**Public Comment No. 824-NFPA 70-2021 [Global Input]**

**Correlating Committee Note No. 367-NFPA 70-2021 [Global Input]****Supplemental Information**

**Public Comment No. 1531-NFPA 70-2021 [Definition: Attachment Fitting, Weight Supporting (WSAF).]****Attachment Fitting, Weight_ Supporting (WSAF).**

Figure Figure Informational Note Figure 100.1 Clothes Closet Storage Space.

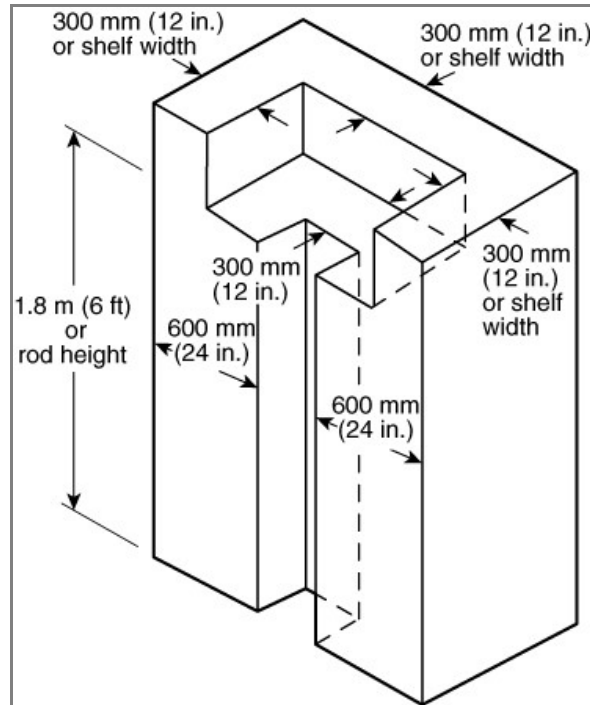
This drawing is a collection of requirements (every measurement being a requirement) and not a definition. it should remain in Article 410.

Figure Figure Informational Note Figure 100.1 Clothes Closet Storage Space.

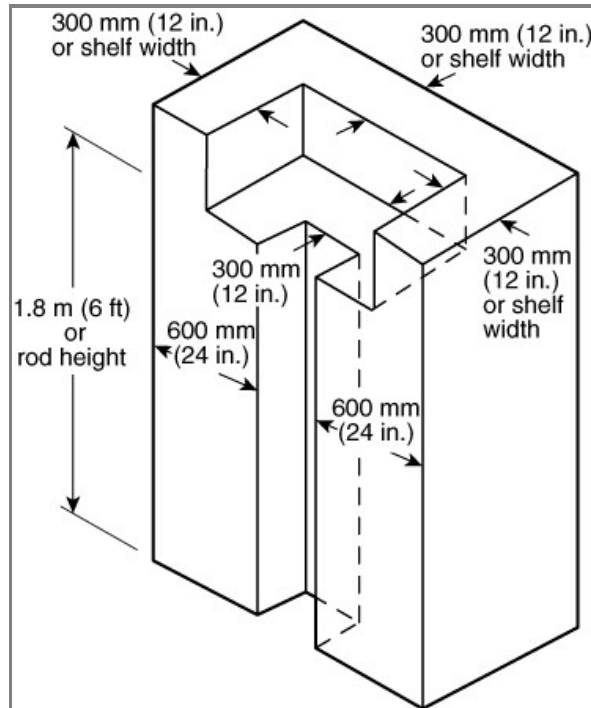
This comment was prepared by a CMP-18 Definitions Task Group consisting of the following members: B. Fahey, C. Kurten, F. Carpenter, J. Potterf, M. O'Boyle, P. Costello, R. Wright, R. Alley. Pursuant to the Technical Correlating Committee direction, the task group reviewed this definition and recommend the suggested changes to align the definition with the NEC Style Manual. The content, including the figure, should be moved to 410.16 as suggested by a companion comment. The suggested changes to the definition provide simplification and clarity.

Figure 4: 14/2 CCA Spaced 12" in R43 Insulation at 10 Amps in Ceiling Configuration

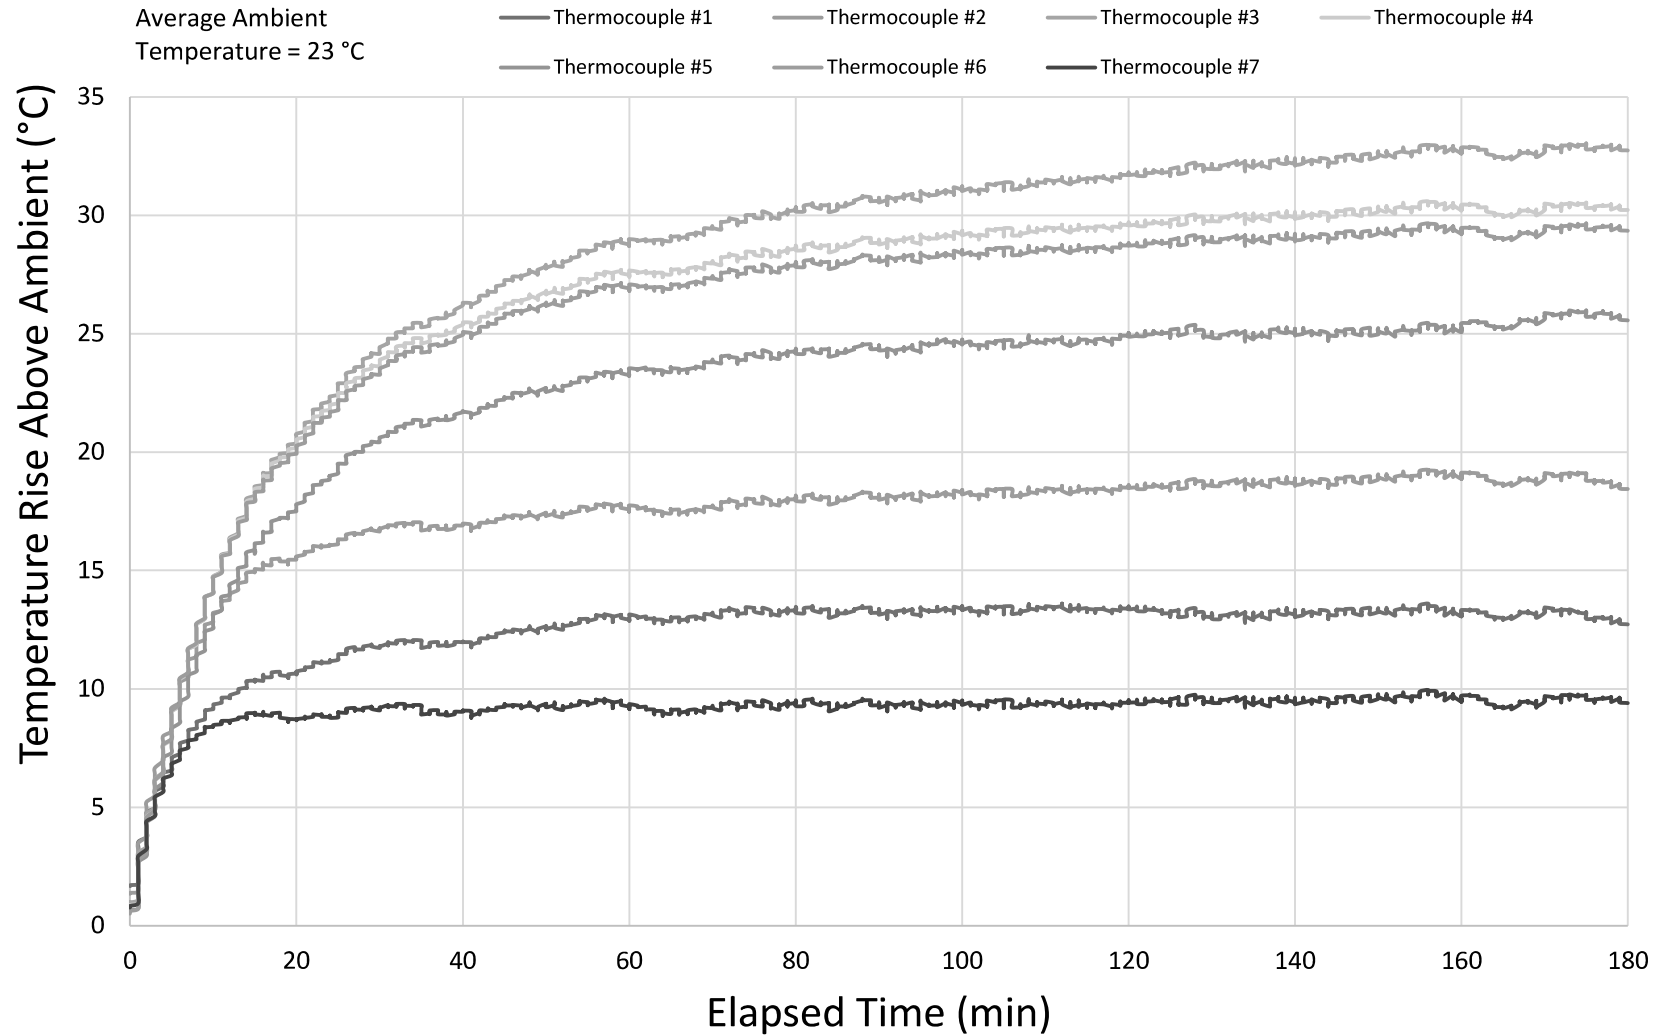
The test results show that the maximum temperature ratings for products made with 14 AWG copper-clad aluminum conductors are exceeded when using the proposed ampacities (testing was performed using 10 Amps at 60 °C for NM-B Cable and 20 Amps at 90 °C for THHN conductors installed in flexible metallic conduit) while the products are installed within insulated walls and ceilings/attics that are typical of residential and commercial installations. It is anticipated that more information (including possible additions to this test report and additional test reports) will be available to the code-making panel from further testing conducted by Southwire and other testing facilities.

The temperature on multiple channels on Figure 2 exceeded the limit of the data logger after approximately 26 minutes. The test lasted for 47 minutes before it was decided to stop testing. The maximum temperature recorded was 102°C above ambient.

See Figures 4 and 5 below for the temperature profile for AWG 14/2 copper-clad aluminum and 14 AWG THHN copper-clad aluminum while the apparatus was in the ceiling orientation. See Figures 6 and 7 for data in the wall orientation.

Figure 410.16 Clothes Closet Storage Space.

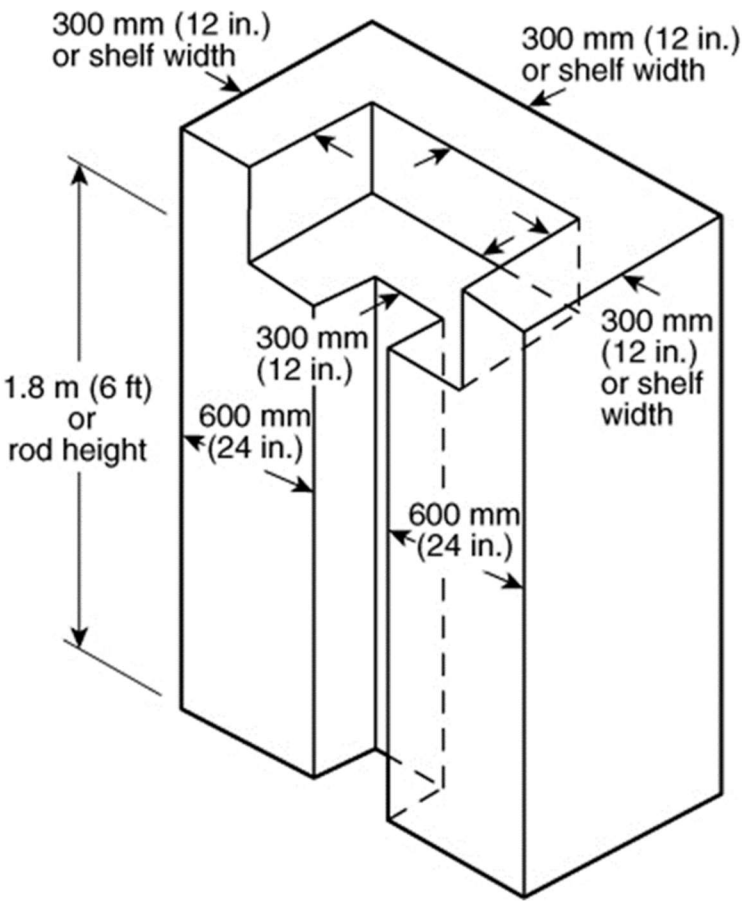
<u>File Name</u>	<u>Description</u>	<u>Approved</u>
Fig_410.16.docx	New Figure 410.16
